# Laurel SUITE ORIGINAL ONLY. (102)

**PURCHASER'S EXTRAS (PE)**  
**Hampton Place - Braylea Investments Inc.**

SUITE 102 - LAUREL (MOD.)

**SCHEDULE "B subsequent"**

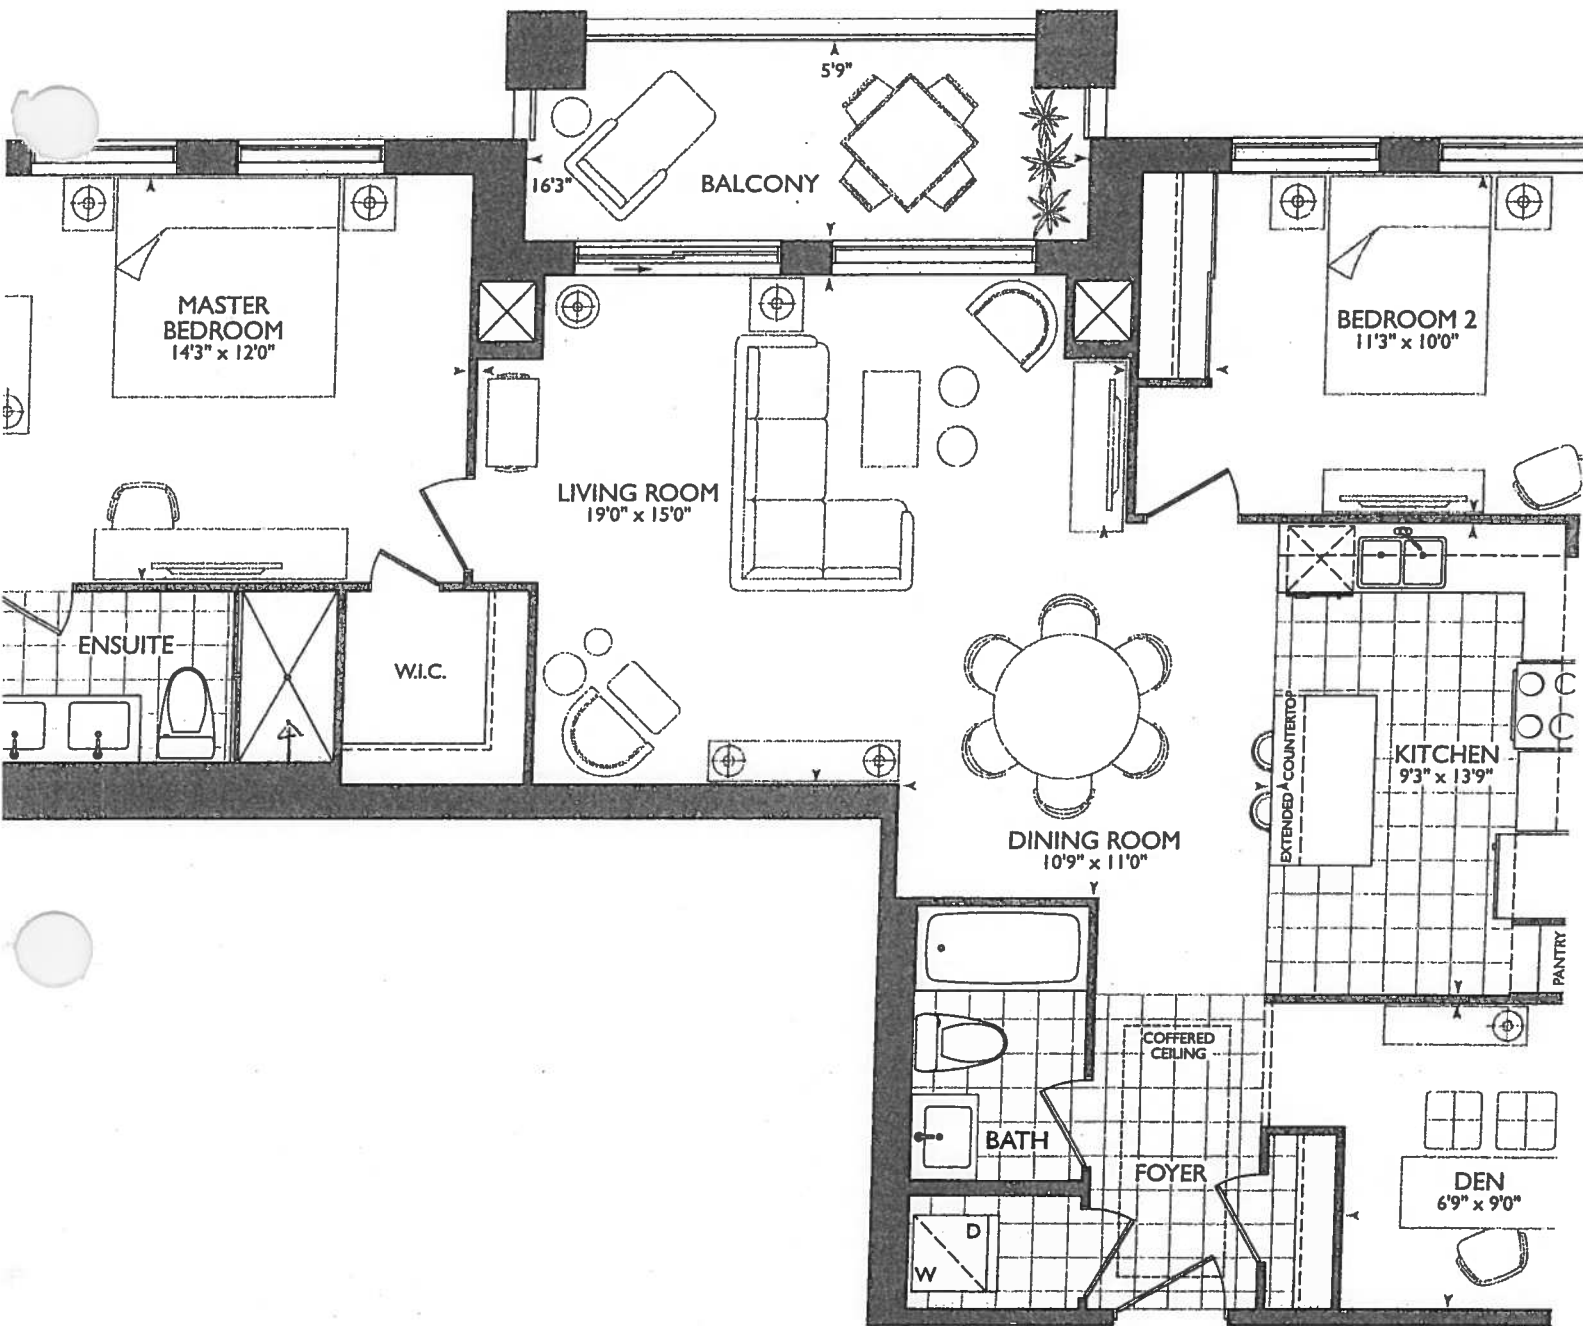
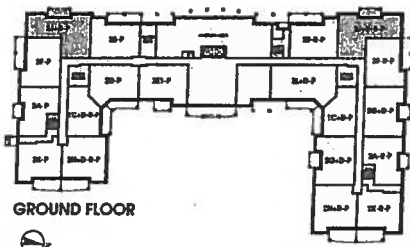
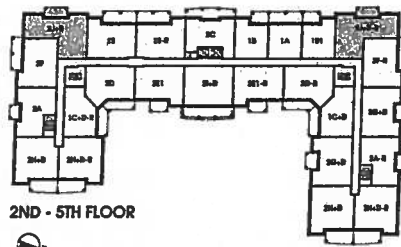
| DESCRIPTION                                                                                                                                                                                                                                                                                                                                                               | AMOUNT |
|---------------------------------------------------------------------------------------------------------------------------------------------------------------------------------------------------------------------------------------------------------------------------------------------------------------------------------------------------------------------------|--------|
| RELOCATE ENTRY CLOSET PLACEMENT. FABRICATE LARGE OPEN NICHE TO ACCOMODATE CLOSET CABINETRY. BLOCK ENTRY TO DEN FROM FOYER.                                                                                                                                                                                                                                                |        |
| FABRICATE SINGLE DOOR OPENING TO DEN FROM KITCHEN. (FOR FUTURE INSTALLATION OF SLIDING BARN STYLE DOOR ON KITCHEN SIDE BY PURCHASER AFTER CLOSING )                                                                                                                                                                                                                       |        |
| ALTER ENTRY DOOR TO BEDROOM 2 TO BE ON ANGLED WALL. ALTER BEDROOM 2 CLOSET AFFECTED BY NEW ENTRY LOCATION. VENDOR TO INSTALL TWO 24 INCH DOORS ON CLOSET.<br>ADD END WALL IN MASTER BEDROOM TO ACCOMODATE FUTURE INSTAL OF WARDROBE CABINETRY AND FIREPLACE BY PURCHASER AFTER CLOSING. RELOCATE ENTRY DOOR TO MASTER ENSUITE. MOVE DOOR 24 INCHES FROM WALL AS PER PLAN. |        |
| VENDOR AGREES TO RELOCATE THE ELECTRICAL PANEL TO A NEW LOCATION AS PER THE ATTACHED SKETCH.                                                                                                                                                                                                                                                                              |        |
| VENDOR TO DROP CEILING IN KITCHEN AS PER PLAN. CROWN MOLDING TO BE INSTALLED IN LIVING/DINING ROOM AS PER VENDORS STANDARD SAMPLES.                                                                                                                                                                                                                                       |        |

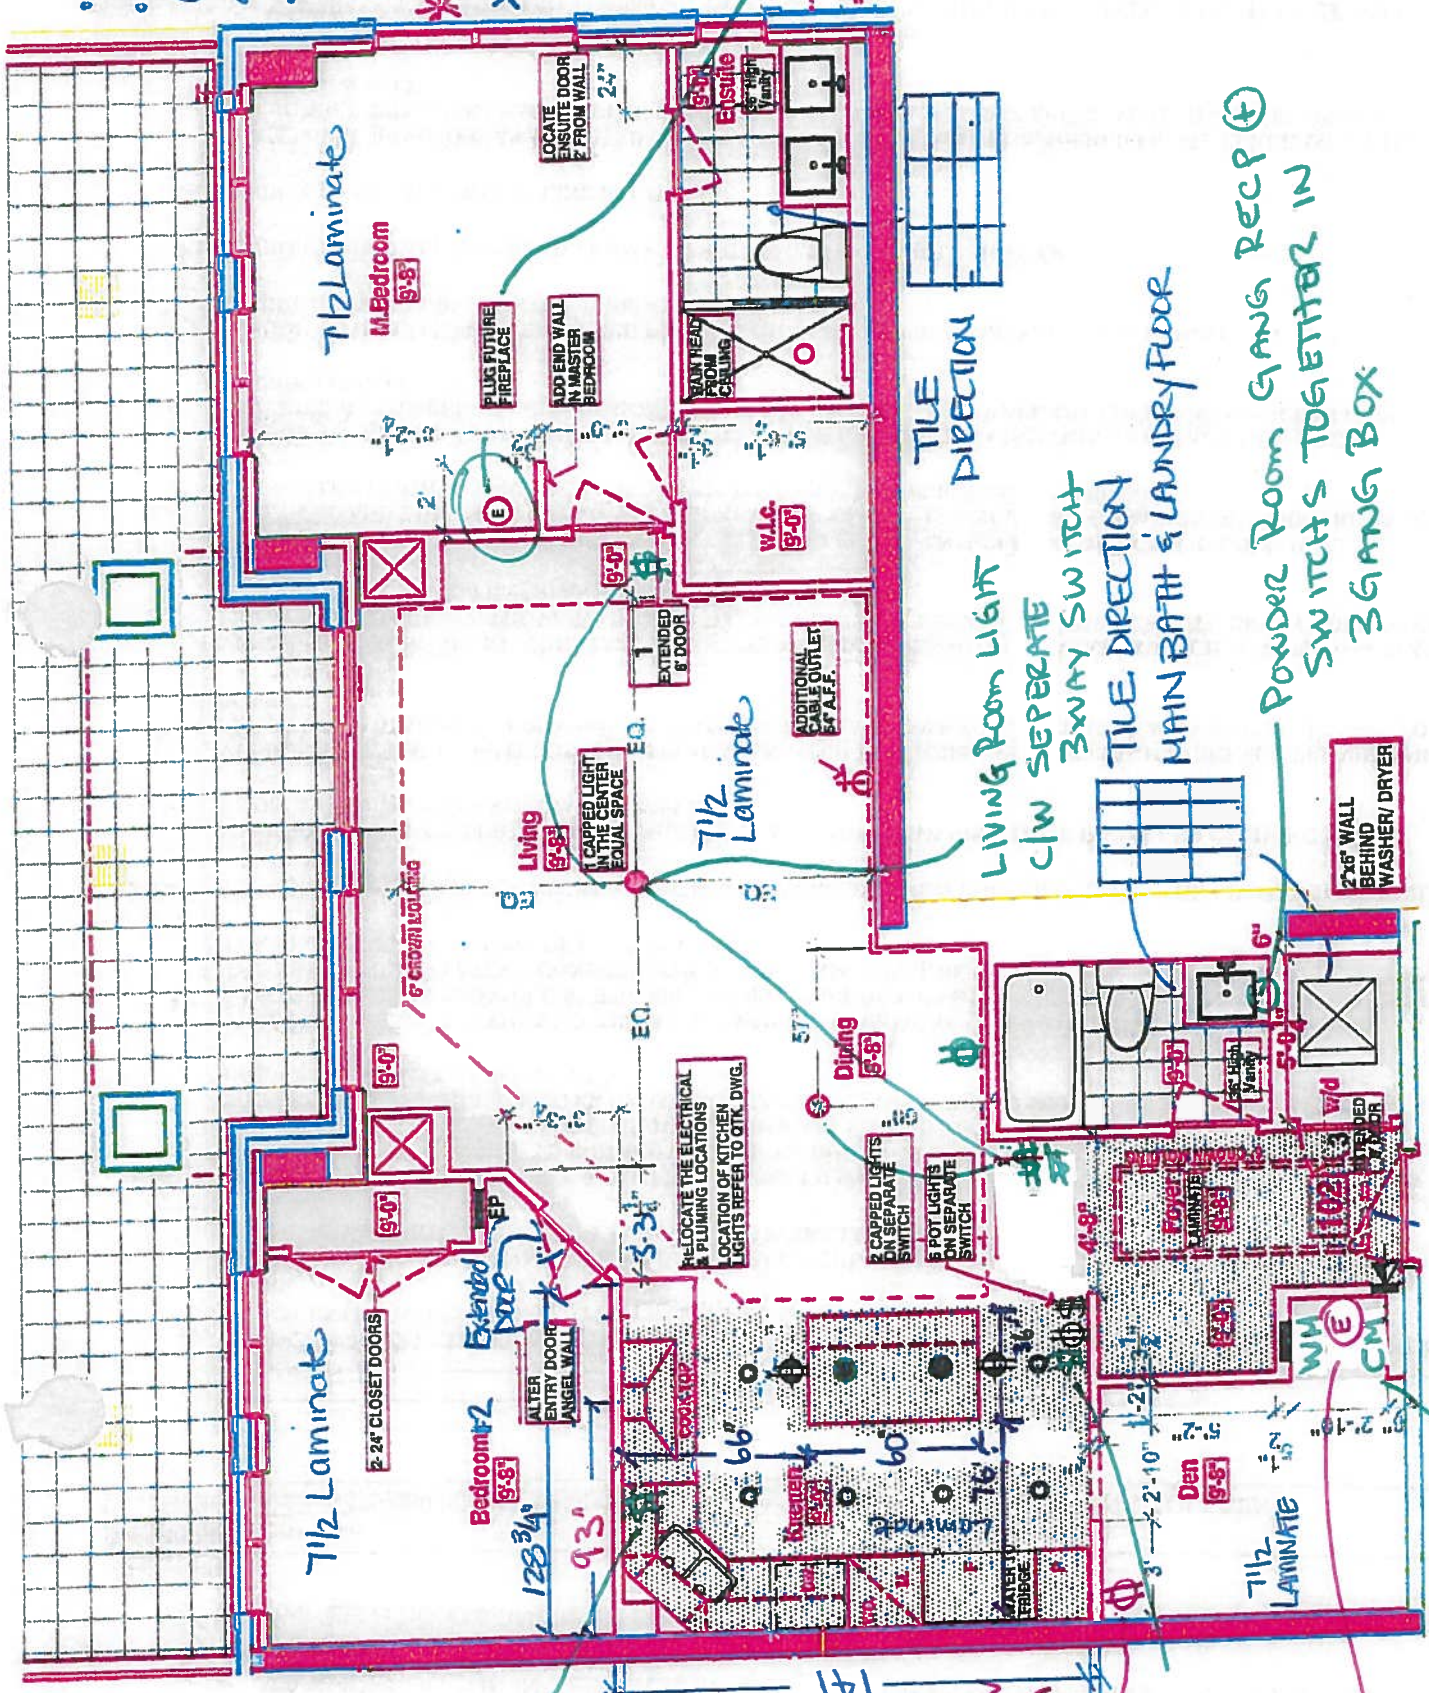
| Item      | QTY | Description                                                                                                                                                                                                                    | Addition to Purchase Price |  |
|-----------|-----|--------------------------------------------------------------------------------------------------------------------------------------------------------------------------------------------------------------------------------|----------------------------|--|
| 1<br>✓    |     | 1 - KITCHEN- Lower the Valance Light Switch to be Located As Per Sketch beside the sink- 2 Gang with Plug<br>Note: Approved As Per Fonzie                                                                                      |                            |  |
| 2<br>✓    |     | 1 - KITCHEN- Upper Valance Light switch to be located when entering the kitchen on a 3 Gang with Kicthen Potlights and pendant lights (As per Sketch)<br>Note: Approved As Per Fonzie                                          |                            |  |
| 3<br>✓    |     | 1 - DEN- Install an additional receptacle at counter height in niche<br>Note: Approved As Per Fonzie                                                                                                                           |                            |  |
| 4<br>✓    |     | 1 - DEN- Communication Panel to be reloacted in the Den as per Sketch and Raise 37" up from the bottom of the panel to the finished floor<br>Note: Approved As Per Fonzie                                                      |                            |  |
| 5<br>✓    |     | 1 - DEN- Add a receptacle and empty conduit C/W pull string for future Valance (As Per Sketch)<br>Note:                                                                                                                        |                            |  |
| 6<br>✓    |     | 1 - DINING ROOM- Relocate the Dining Room switch behind the Powder Room Tub in the Hallway (As Per Sketch Attached)<br>Note: Approved As Per Fonzie                                                                            |                            |  |
| 7<br>✓    |     | 1 - LIVING ROOM- Living Room Light c/w on a seperate 3 Way Switch (As Per Sketch)<br>Note: Approved As Per Fonzie                                                                                                              |                            |  |
| 8<br>✓    |     | 1 - POWDER ROOM- Install a 3 Gang switch and receptacle together beside the Vanity (As Per Sketch)<br>Note: Approved As Per Fonzie                                                                                             |                            |  |
| 9<br>✓    |     | 1 - MASTER BEDROOM- Provide a seperate circuit for future fireplace. Install a 15Amp, 125V (As Per Sketch)<br>Note: Approved As Per Fonzie                                                                                     |                            |  |

Provide SEPERATE CIRCUIT FOR FUTURE FIREPLACE 15A 125V

LOWER VALANCE SWITCH 2 GANG, X PLUG

ADD REC. AND EMPTY CONDUIT CLW PULL STRING

UPPER VALANCE SWITCH

ADDITIONAL REC @ Counter Height.

• COMMUNICATION PANEL RAISE 37" BOTTOM OF FINISHED FLOOR

MASTER ENSUITE

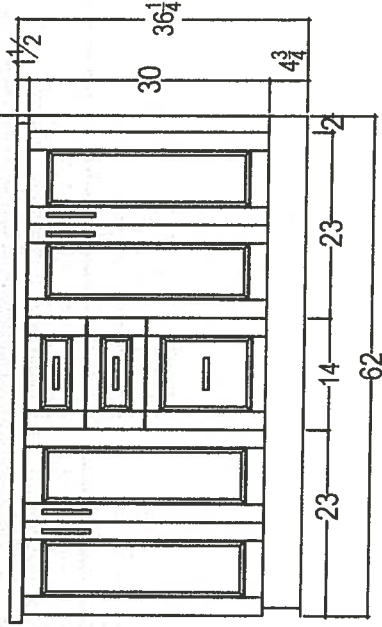
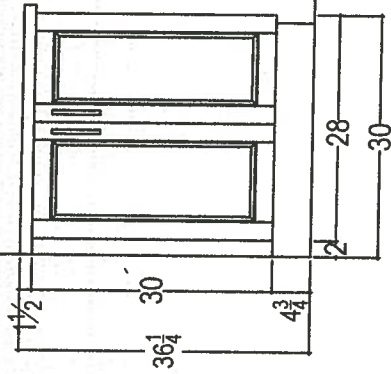
| <p>1 - CLARIFICATION:<br/>MASTER ENSUITE &amp; MAIN BATH-Install RAISED VANITY HEIGHT at Main Bath and Master Ensuite Vanities, where applicable (See attached QTK Upgrade paperwork and Layouts)</p> <p>Note:</p>                              |
| <p>1 - CLARIFICATION-<br/>MASTER ENSUITE / MAIN BATH- DELETE the Standard 3" Splash throughout all bathroom vanity counter tops, where applicable. To include the bath and the Master Ensuite</p>                                               |

~~\* R~~aised VANITIES  
~~W~~ NO  
 3" SPLASHT

\* MASTER ENSUITE \*

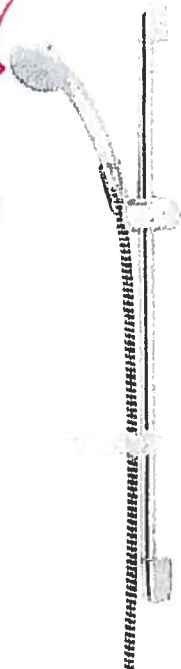
| DESCRIPTION                                                                                                                                                                                                                                                                                                                                                               | AMOUNT |
|---------------------------------------------------------------------------------------------------------------------------------------------------------------------------------------------------------------------------------------------------------------------------------------------------------------------------------------------------------------------------|--------|
| VENDOR TO INSTALL RAINHEAD FROM CEILING IN MASTER ENSUITE SHOWER.                                                                                                                                                                                                                                                                                                         |        |

SHOWER  
HEAD  
FROM  
CEILING

Delta Shower Trim ~~with Tub Spout~~ and  
Hansgrohe Slide Bar with Handheld and  
\* CEILING \* ~~Wall~~ Mount Showerhead  
#R10000/T13020-CDN/27454002/  
27744000/RP52382/RP46870/RP6025/  
R11000/T11800

Suite 102 Hampton  
Revised: April 4, 2019

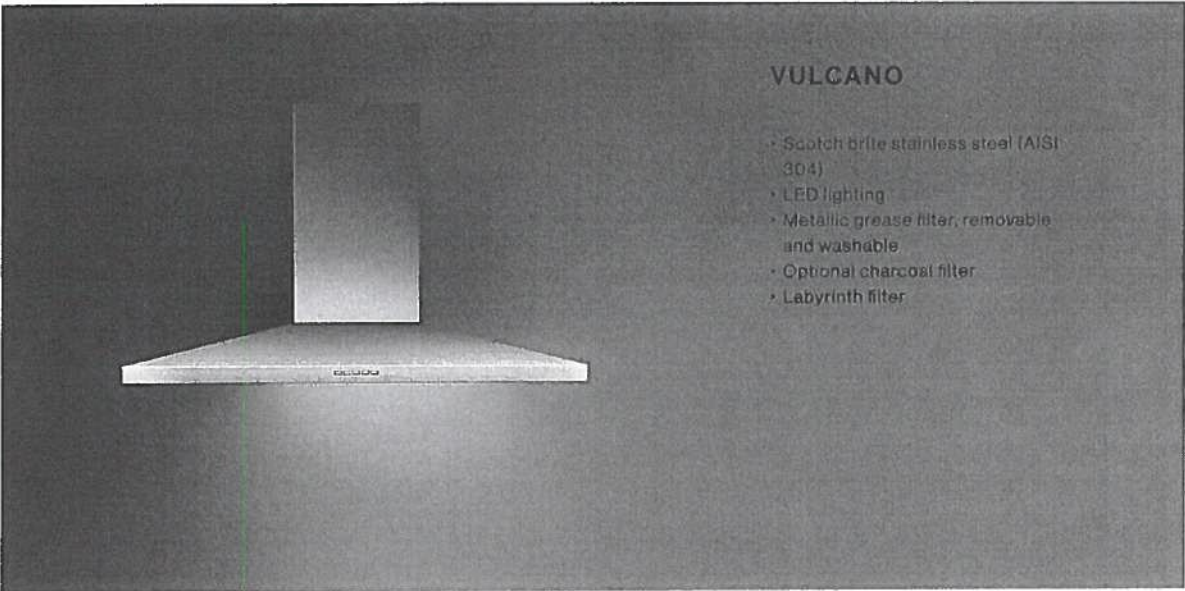
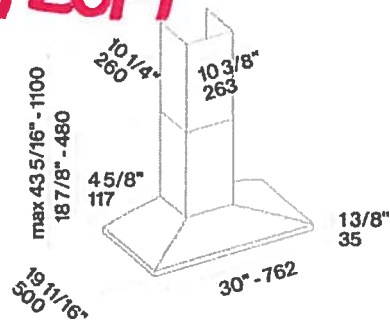
| Item | QTY | Description                                                                                                                                                                                          | Addtion to Purchase Price |  |
|------|-----|------------------------------------------------------------------------------------------------------------------------------------------------------------------------------------------------------|---------------------------|--|
| 1    |     | 1 - KITCHEN- Purchaer accepts and acknowledges that the Chimney Style exhaust fan chosen at time of colour chart has been replaced with the Falmec Vulcano<br>Note: As per Head Office               |                           |  |
